West Beverley Street Sidewalk Improvements and VDOT SGR Repaving

Addendum #1

VDOT Project No's.: 0254-132-373, 0254-132-374, 0254-132-375, 0254-132-376, PR21-132-368
UPC's: 121201, 121203, 121204, 121205, 116962
HUD/DHCD No.: 2019/10-18; 2021/5-45; 2023/4 (West Beverley Street New Sidewalk)

Subject: **Addendum #1 to IFB D00224 dated April 2024**

Draw No.
M-5(H)

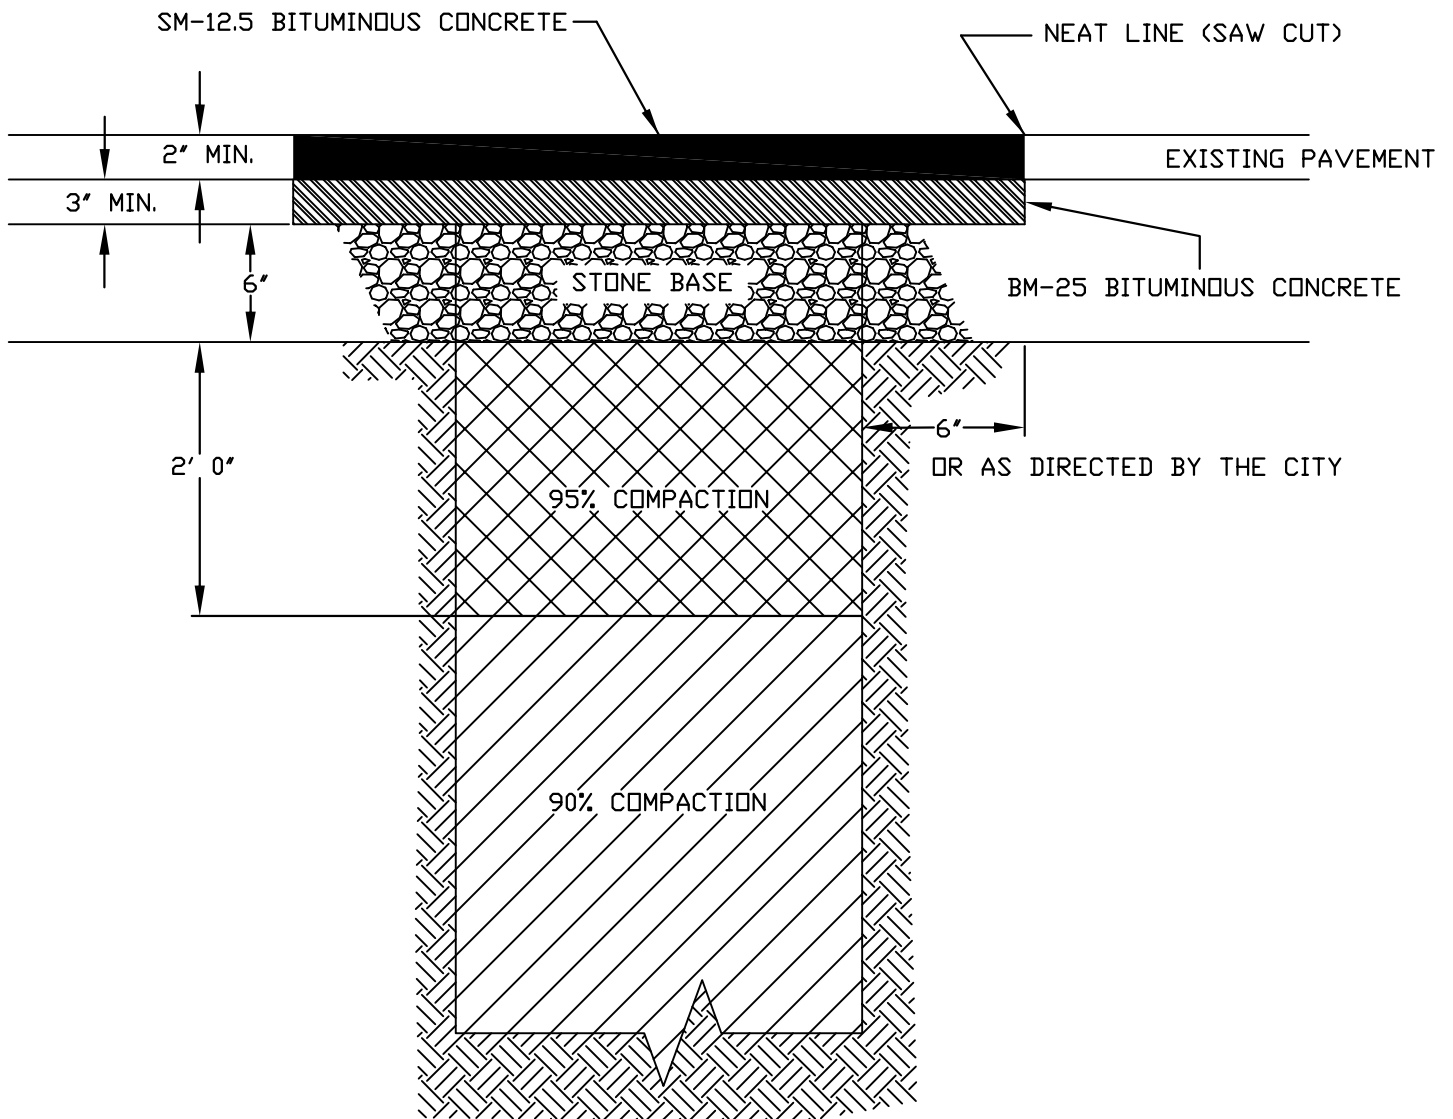
1. Q: I don't see any detail for the patch back in front of the curb cuts. I assume some stone, base, then surface but not sure of the requirements. Usually, it's a 2' cut that allows for proper compaction in front. Can you please provide this detail?
A: The contractor should utilize the City of Staunton Heavy Duty Patch for Asphalt Pavement M-5(H) to patch the curb cut locations, included in this Addendum. Saw cut should occur 2' out from the proposed curb/gutter outside dimension.

1. COMPLETED PATCH TO BE FLUSH WITH EXISTING PAVEMENT

02

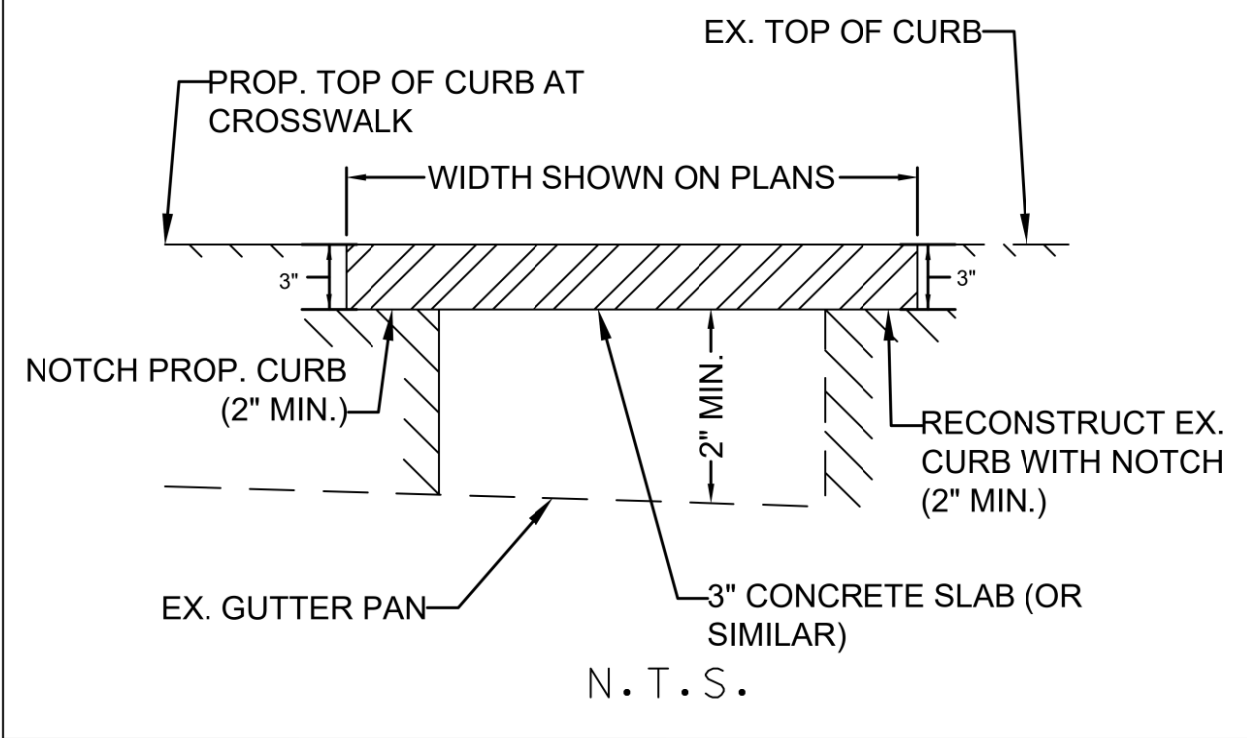
5. Q: Excavation Note #1 on Sheet 2 seems to indicate that removal of sidewalk and Curb/Gutter will be paid as regular excavation but the bid form has separate bid items for removal of sidewalk and removal of curb. Can you please give instruction on how the demo of existing concrete will be paid?
A: Please disregard the referenced Excavation Note #1 on Plan Sheet 02 of the Sidewalk Improvement Plans and utilize the quantities as denoted in the bid sheet

6. Q: Excavation note #3 on sheet 02 indicates that there will be no payment for saw cutting but there is a pay item for saw cutting asphalt. Will the contractor be paid for this? Will the contractor be paid for saw cutting concrete?

7. Q: Excavation note 6 on sheet 02 says that stone is included in the price of curb installation. There is a pay item for stone. Please clarify how this will be paid.

and Plan Sheet 2A for removal of sidewalk, entrances, and curb/gutter; see also Answer to Question #2 above. Plan Sheet 02 of the Sidewalk Improvement Plans has been revised accordingly and is included with this Addendum.

A: Please disregard the referenced Excavation Note #3 on Plan Sheet 02 of the Sidewalk Improvement Plans and utilize the quantities as denoted in the bid sheet and Plan Sheet 2A for saw cut; see also Answer to Question #2 above. Plan Sheet 02 of the Sidewalk Improvement Plans has been revised accordingly and is included with this Addendum. Additionally, the quantity for Bid Item A7 has been revised; see revised Bid Form.

A: Please disregard the referenced Excavation Note #6 on Plan Sheet 02 of the Sidewalk Improvement Plans and utilize the quantities as denoted in the bid sheet and Plan Sheet 2A for stone; see also Answer to Question #2 above. Plan Sheet 02 of the Sidewalk Improvement Plans has been revised accordingly and is included with this Addendum.

1. ~~REGULAR EXCAVATION SHALL INCLUDE THE MATERIAL, EQUIPMENT AND LABOR NECESSARY TO EXCAVATE THE EXISTING GROUND AND SIDEWALK, CURB AND GUTTER TO THE APPROPRIATE SUBGRADE NECESSARY FOR THE PROPOSED IMPROVEMENTS. REGULAR EXCAVATION SHALL ALSO INCLUDE THE DISPOSAL OF EXISTING PAVEMENT, CURB AND GUTTER, DRAINAGE STRUCTURES, PIPE, SURPLUS MATERIAL, SIDEWALK, ETC. DESIGNATED TO BE REMOVED. THESE ITEMS MUST BE REMOVED FROM THE WORK SITE AND DISPOSED OF AT AN APPROVED SITE SECURED BY THE CONTRACTOR. COST FOR THIS WORK IS TO BE INCLUDED IN REGULAR EXCAVATION. REGULAR EXCAVATION WILL BE PAID ON A PLAN QUANTITY BASIS PLUS APPROVED EXTRA EXCAVATION.~~

3. ~~PRIOR TO ANY EXCAVATION, THE PAVEMENT AND ANY OTHER HARD SURFACE MUST BE SAWCUT TO PREVENT DAMAGE TO THE ITEMS TO REMAIN. NO SEPARATE PAYMENT WILL BE MADE FOR SAW CUTTING. THE COST FOR SAW CUTTING (DRIVEWAYS, PAVEMENT, SIDEWALKS, AND CURB AND GUTTER) SHALL BE INCLUDED IN OTHER ITEMS.~~

6. ~~EXCAVATION FOR INSTALLATION OF CURB (ROAD SIDE) TO BE FILLED WITH COMPACTED 2 1/4 GRAVEL TO WITHIN 2" OF FINAL GRADE. TO BE INCLUDED IN UNIT PRICE OF CURB & GUTTER OR SIDEWALK.~~
